RE: Blythe Energy Project Transmission Line (99-AFC-8C)
Metropolitan Water District Letters Regarding Insignificant Project Change Request #3

**Request for Approval of Third
Insignificant Project Change
(99-AFC-8C)**

**Blythe Energy Project
Transmission Line**

**Minor Structural Changes, Additional Communications
Systems, and Expanded Work Areas**

Figure 2-6. Edison Proposed 120-Foot Communication Tower

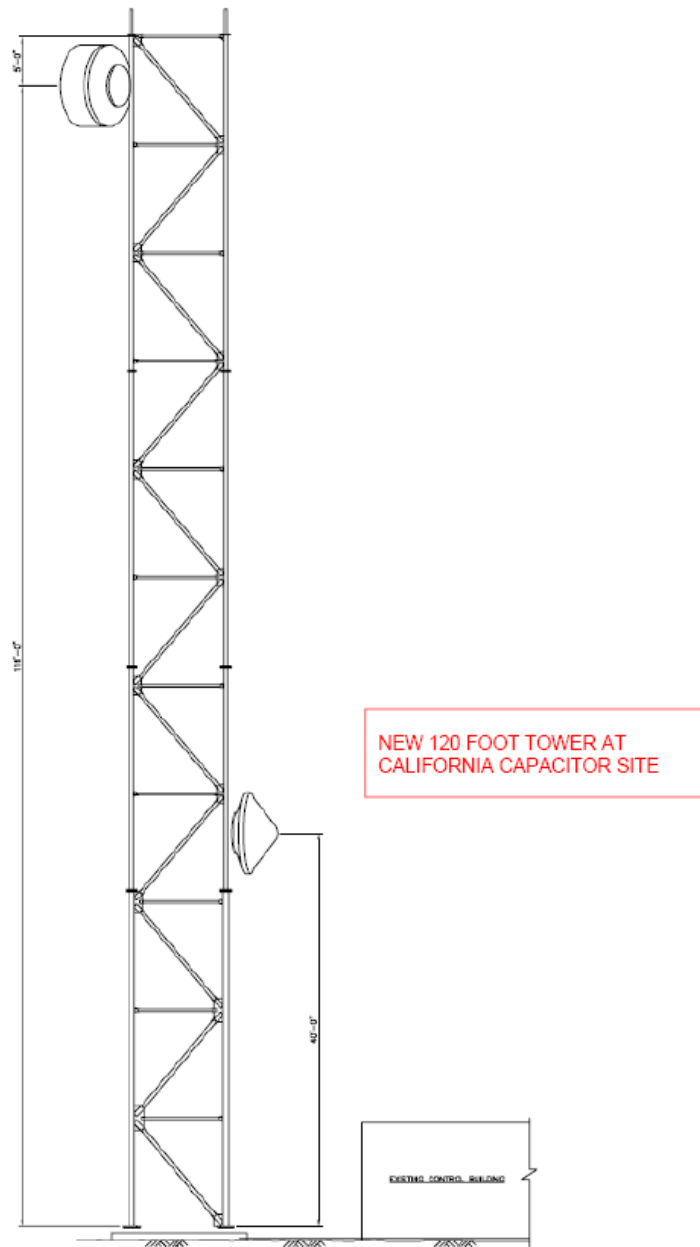
Figure 2-5 and 2-6 illustrate the location of the requested change of microwave tower at the Edison-owned California Capacitor Station (CalCap). The CalCap is located just south of I-10 at the Red Cloud Road exit. The nearest BEPTL structures are 369 and 370. There is an existing unsurfaced road that accesses the CalCap, which is located on public land administered by the BLM in Township 6S, R14E, SW ¼ of the SE ¼ of Section 6, San Bernardino Base & Meridian. The CalCap is a permitted use of public lands under case file #CA4163. Edison will request an amendment to their ROW Grant to accommodate the proposed tower change.

Edison will replace an existing 20-foot microwave tower with a new 120-foot tower (Figure 2-6) just west of the Mechanical Electrical Equipment Room (MEER) inside the existing fence line of the CalCap.

Edison stated that the new tower is needed to provide a diverse communications link from the SCE Telecommunication network to Julian Hinds, to meet SCE's protective relaying requirements. The tower is planned at 120 feet in height to clear the 500-kV switch rack at California Capacitor.
